## Development Permit Panel

#### 2. Development Permit 09-506909

PROPERTY LOCATION: 6331 and 6351 Cooney Road

Permit the construction of a 14-story tower with roof deck containing 77 apartment dwellings and 2 live/work units at 6331 and 6351 Cooney Road on a site zoned "High Rise Apartment (ZHR8) Brighthouse Village".

ATTACHMENT 3: EDGE CONDITIONS (NORTH PROPERTY LINE) - 8288 SABA ROAD

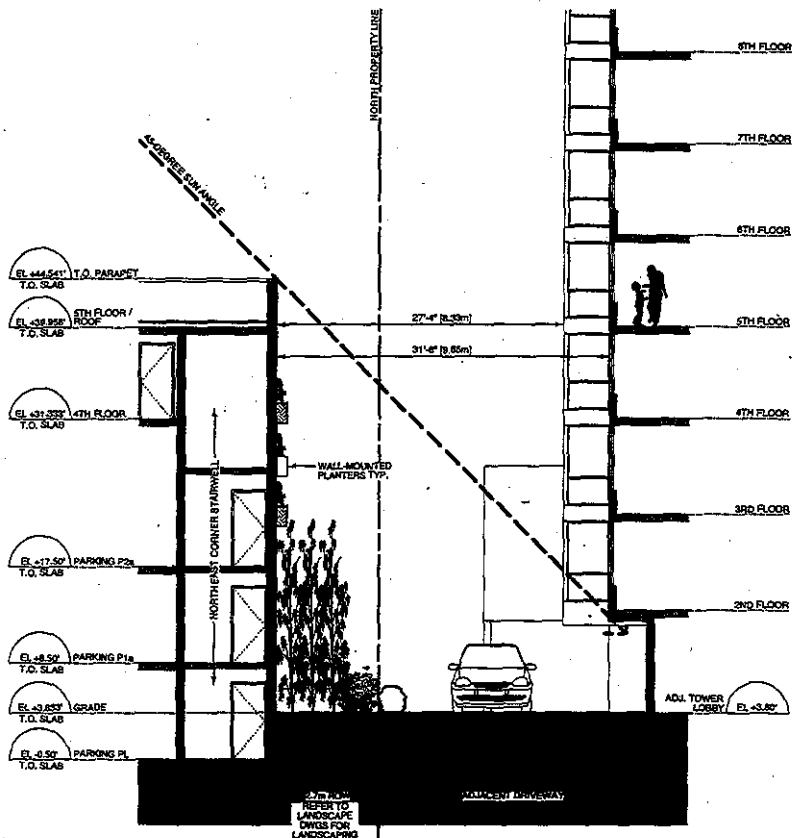
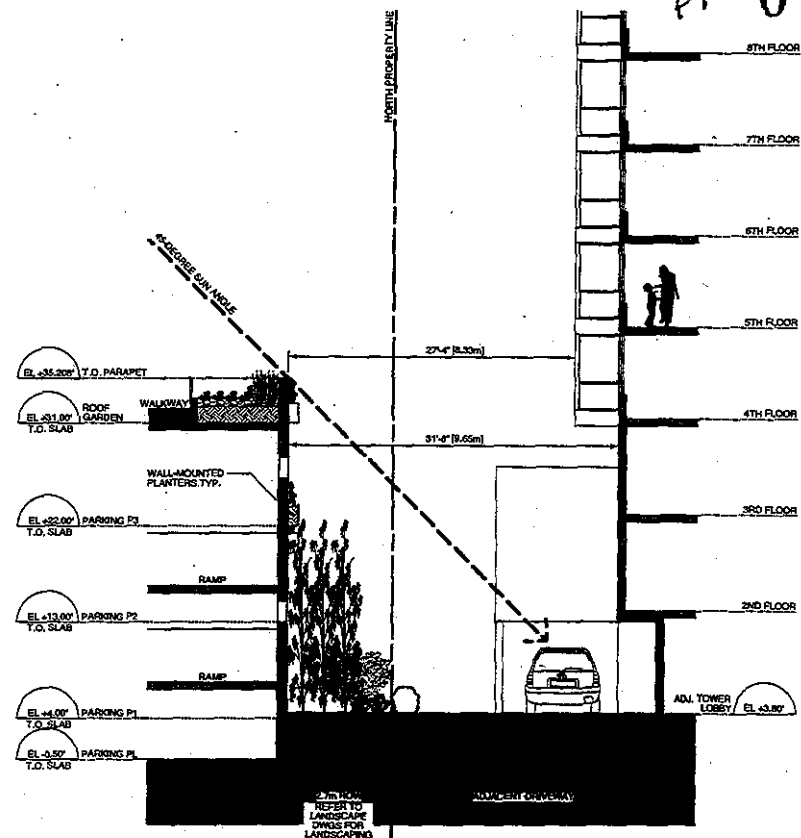
North Edge: The separation from the proposed parking structure and the bay windows of the adjacent residential tower to the north of the proposed development at 8288 Saba Road is 8.33m and 9.65m to the base plane of the tower. The 2<sup>nd</sup> and 3<sup>rd</sup> storey south facing apartment units near the southeast corner of the residential tower located at 8288 Saba Road will directly face the proposed parkade north wall. This interface is being addressed by the proposed development as follows:

- voids or openings in the parking structure walls;
- horizontal planters attached to the parkade walls complete with trellis systems and vines,
- introduction of frosted windows in the stairwell of the parkade,
- tall bamboo planting along the east half of the parkade wall will alleviate views from the lower apartment units in the adjacent residential tower (see **Attachment 3**).
